Division of Reclamation,
Mining and Safety

Re: December 20, 2018 Inspection Report (Revised), Cresson Project, Permit No. M-1980-244

REVISED MINERALS PROGRAM INSPECTION REPORT
PHONE: (303) 866-3567

MINE NAME: Cresson Project	MINE/PROSPECTING ID#: M-1980-244	MINERAL: Gold	COUNTY: Teller
INSPECTION TYPE: Monitoring	INSPECTOR(S): Elliott R. Russell	INSP. DATE: December 20, 2018	INSP. TIME: 09:00
OPERATOR: Cripple Creek & Victor Gold Mining Company	OPERATOR REPRESENTATIVE: Justin Raglin and Erik Munroe	TYPE OF OPERATION: 112d-3 - Designated Mining Operation	
REASON FOR INSPECTION: Normal I&E Program	BOND CALCULATION TYPE: None	BOND AMOUNT: \$208,491,188.00	
DATE OF COMPLAINT: NA	POST INSP. CONTACTS: None	JOINT INSP. AGENCY: None	
WEATHER: Clear	INSPECTOR'S SIGNATURE: 	SIGNATURE DATE: February 13, 2019

Photo 4. Access road in northwest portion of the AGVLF, edge of liner approximated by the dashed yellow line, area where storm water swale needs some work circled in red; looking south.

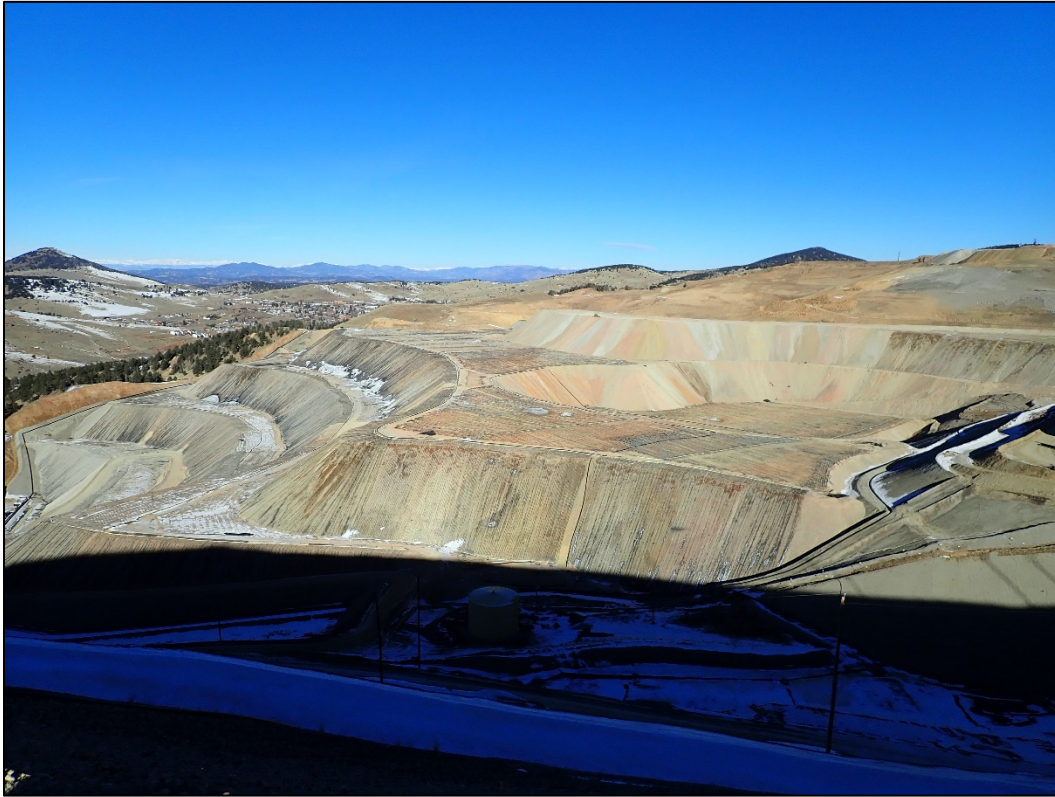
The Division inspected an access road which leads off of the northwest side of the AGVLF. This area poses a potential for storm water from AGVLF to leave the lined area. The Operator has previously installed an adequate swale in the access road to keep storm water on the liner and behind the edge of liner berm, however with time this swale has been reduced and appears in need of reworking (**Photo 4**). The Division also recommends the Operator establish edge of liner signage on either side of the access road to alert those using the access road the location of the edge of liner.

Photo 9. Recently installed Edge of Liner signs in the northwest portion of SGVLF; looking southwest.

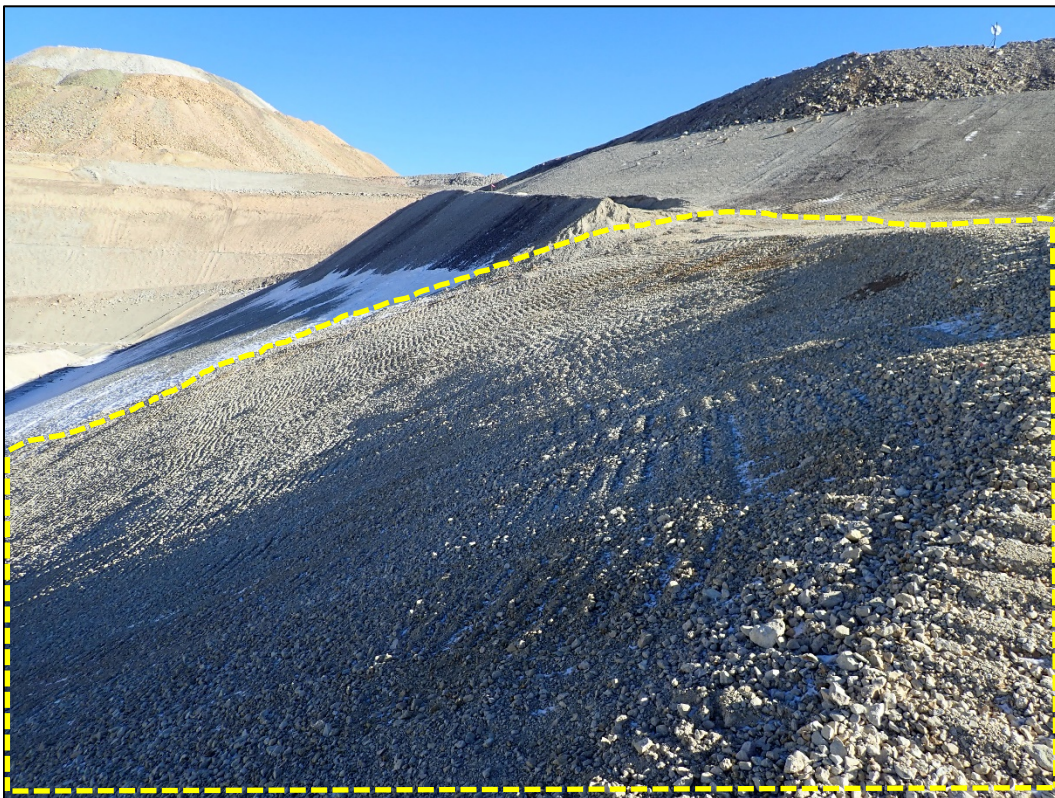
The Division observed the northwest portion of the SGVLF where, during the normal monitoring inspection on November 29, 2018, the Division had identified the need for edge of liner signs. The edge of liner had been surveyed and adequate signage was posted (**Photo 9**). This observation resolved the compliance problem cited in the November 29, 2018 inspection report.
